Title: MTO2017 915iS Intercooler Mounting Assembly	
AG-SB-2020-03-B-EN	
Applicability	
Aircraft type & model: AutoGyro MTO2017	Affected Serial number(s): All MTO2017 fitted with the Rotax 915iS engine
The maintenance manual to be referenced is this stated or subsequent issue.	
As per AutoGyro website	
<p>This form is the response from AutoGyro GmbH either against a problem found in the product in service requiring a containment or rectification action, or as service information for aircraft modification incorporation. For help, contact AutoGyro on 49(0)5121 88056-00, or email airworthiness@auto-gyro.com.</p>

Reason and overview of the Service Bulletin (cause of problem if known)

(Pic. 1)

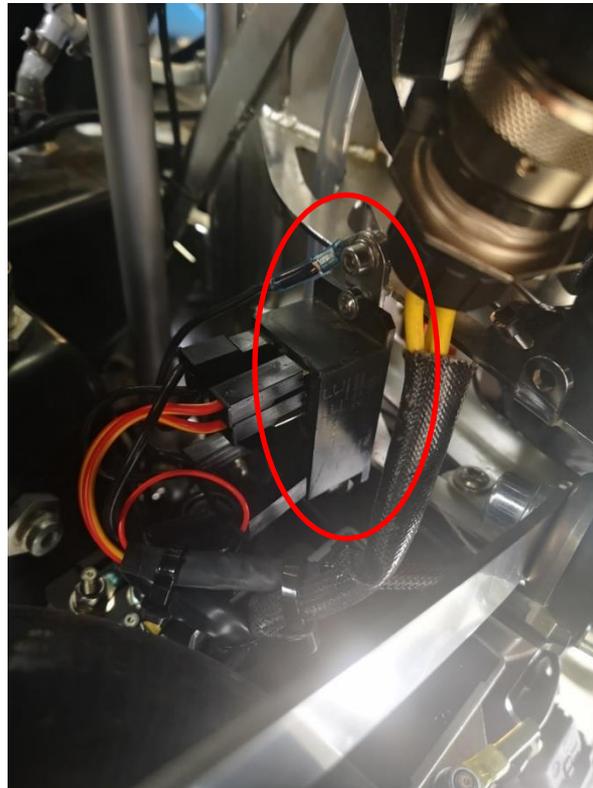
3. Support the engine using its lifting points. Rotax 915 series installation manual ch. 10-10-00 'Engine Handling' refers.
4. Disassemble the blow-off valve from the upper left engine mount (Pic. 1) and secure in an appropriate position to allow access to the engine mounting bolt head.

(Pic. 2)

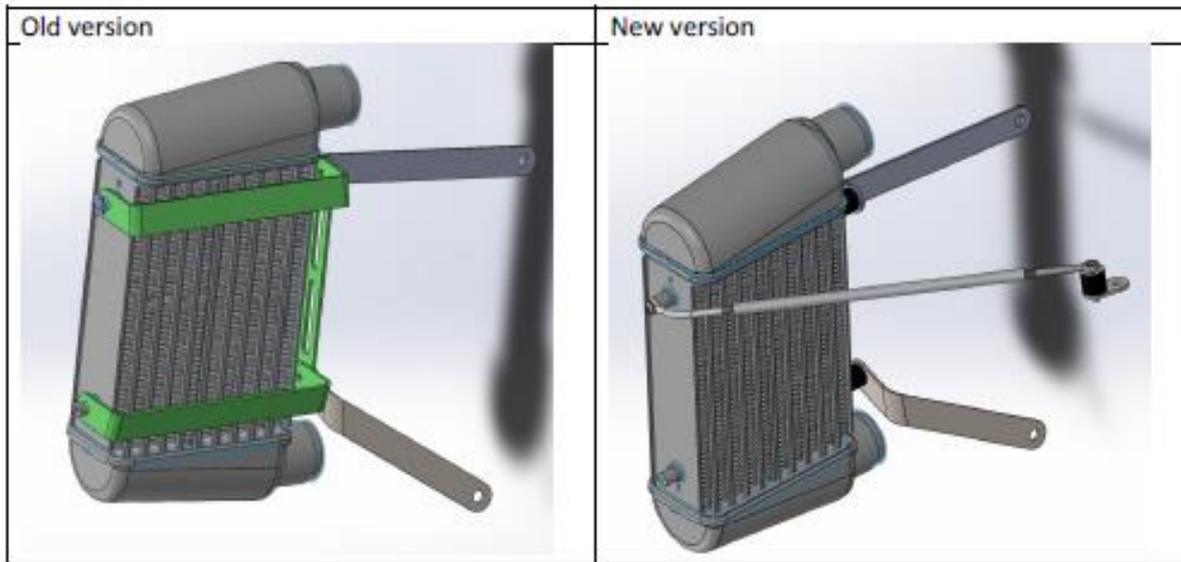
5. Disassemble the relay from the lower left engine mount (pic. 2) and secure in an appropriate position to allow access to the engine mounting bolt head.

(Pic. 3)

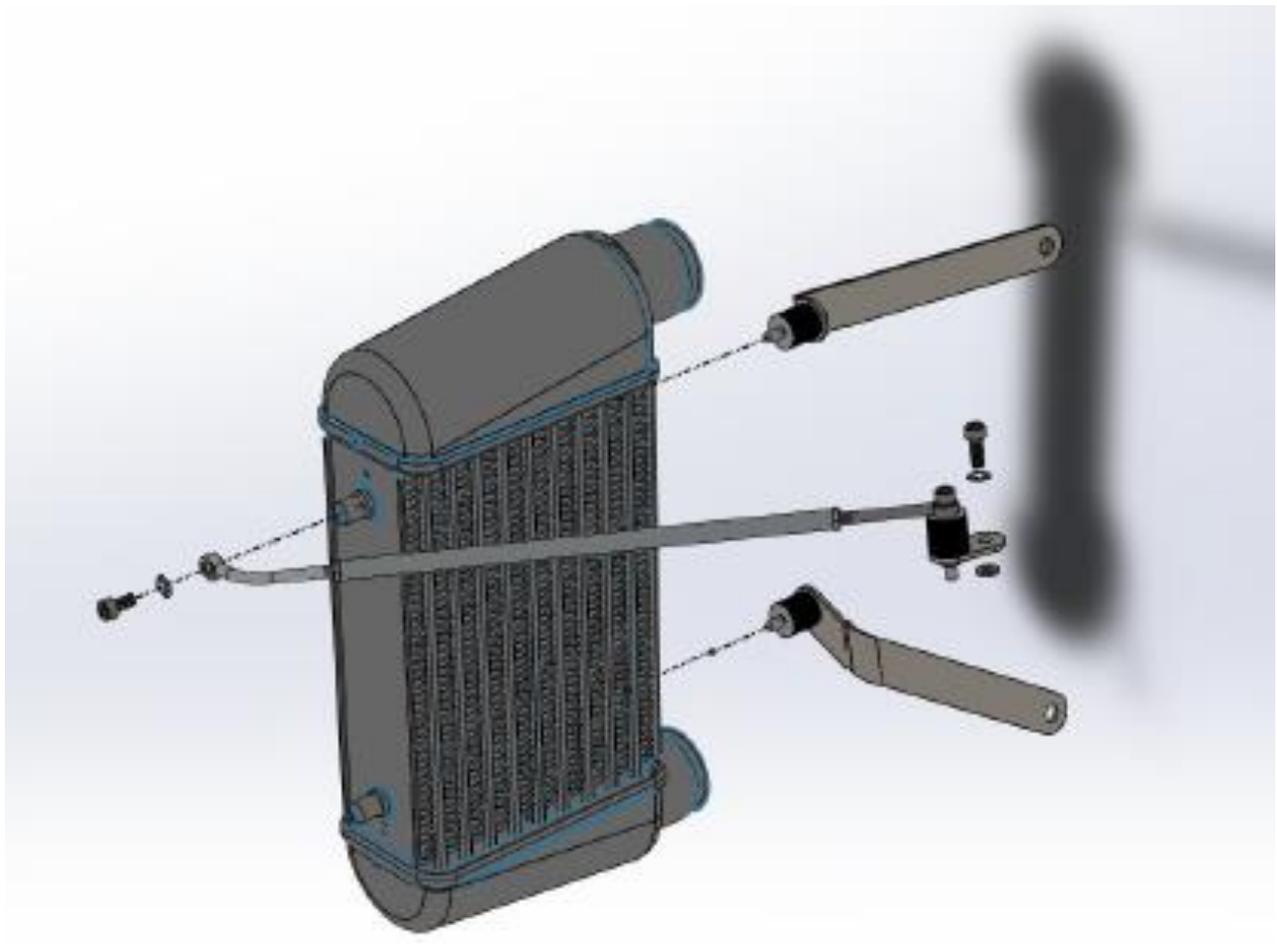
6. Remove the intercooler support frame (Pic. 3 – old version, green items)
7. Ensure the engine is supported and remove the upper and lower engine mounting bolts in accordance with AMM Job Card 71-20-00 8-1.

8. Remove the intercooler support arms from the engine bolts.
9. Assemble the new intercooler support assembly arms from set 47913 to the upper and lower engine mounting bolts as per the diagram in Pic. 4.
